UNITED STATES  
NUCLEAR REGULATORY COMMISSION  
WASHINGTON, D.C. 20555-0001

SAFETY EVALUATION BY THE OFFICE OF NUCLEAR REACTOR REGULATION

REGARDING RESULTS OF THE REINSPECTION OF THE CORE SHROUD

NINE MILE POINT NUCLEAR STATION, UNIT 1

Figure 1-1 NMP1 Shroud Weld Locations, Cross Sectional View

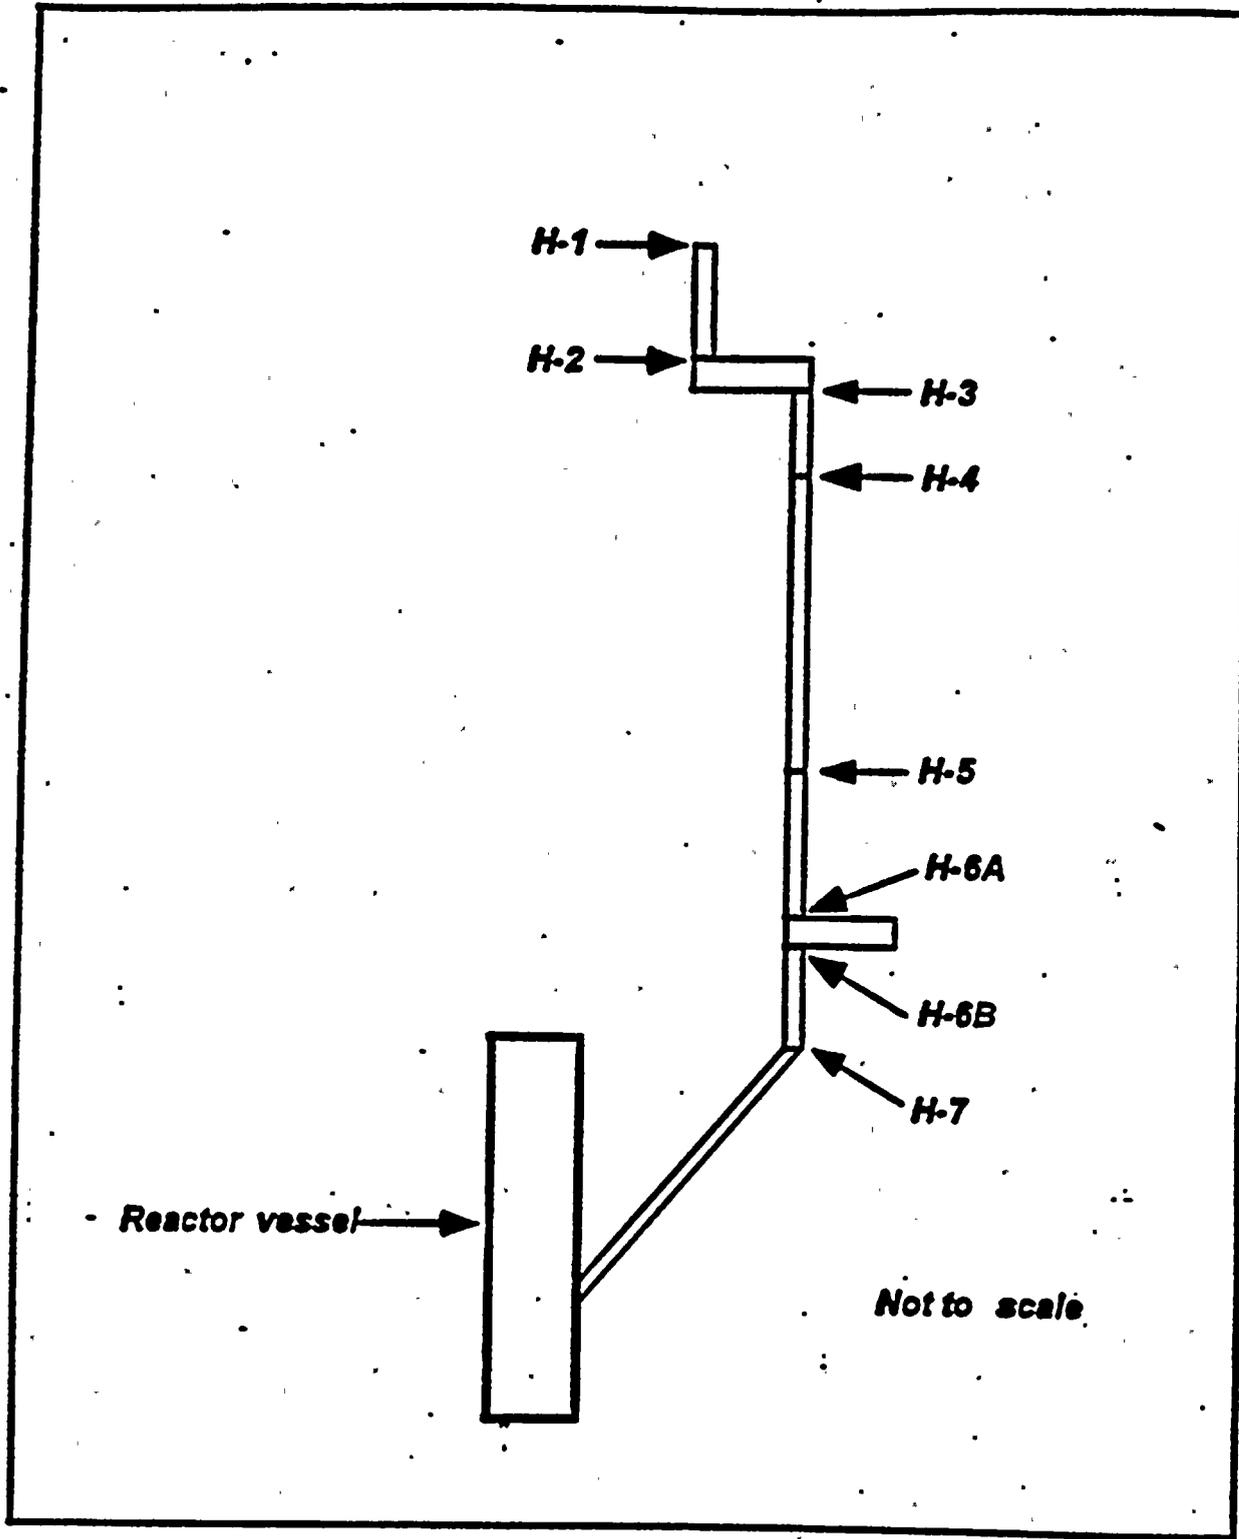
Figures 1-1 and 1-2 show the location of the shroud welds.<sup>1</sup> Table 2-2 shows the findings for vertical weld inspections. NMPC did not present a table of findings for the horizontal welds, but provided examination indication maps

Figure 1-2 NMP1 Shroud Weld Locations

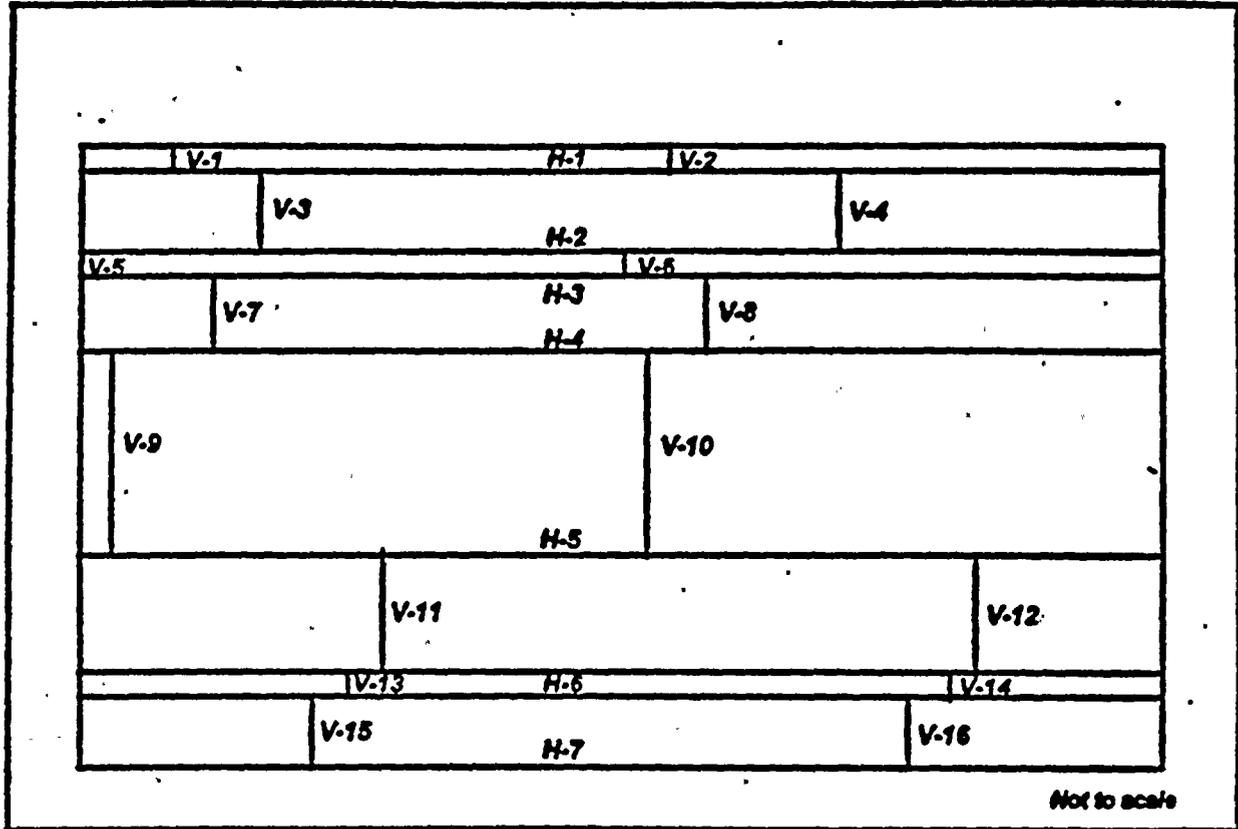
The ring segment welds (labeled in Figure 1-2 as V5 and V6) were excluded from the vertical welds requiring inspection based on a GE analysis of the ring segment welds submitted to the NRC staff for review by letter dated February 7, 1997.

NMPC presented detailed descriptions and examination indication maps of the vertical weld cracking. The results are summarized in Table 2-2 and are included in Appendix C (attached). The inspections showed significant cracking on welds V4, V9, and V10. Minor cracking was found on welds V3, V12, V15, and V16. No cracking was found on the accessible areas of welds V7, V8, and V11. Welds V5 and V6 were not located.
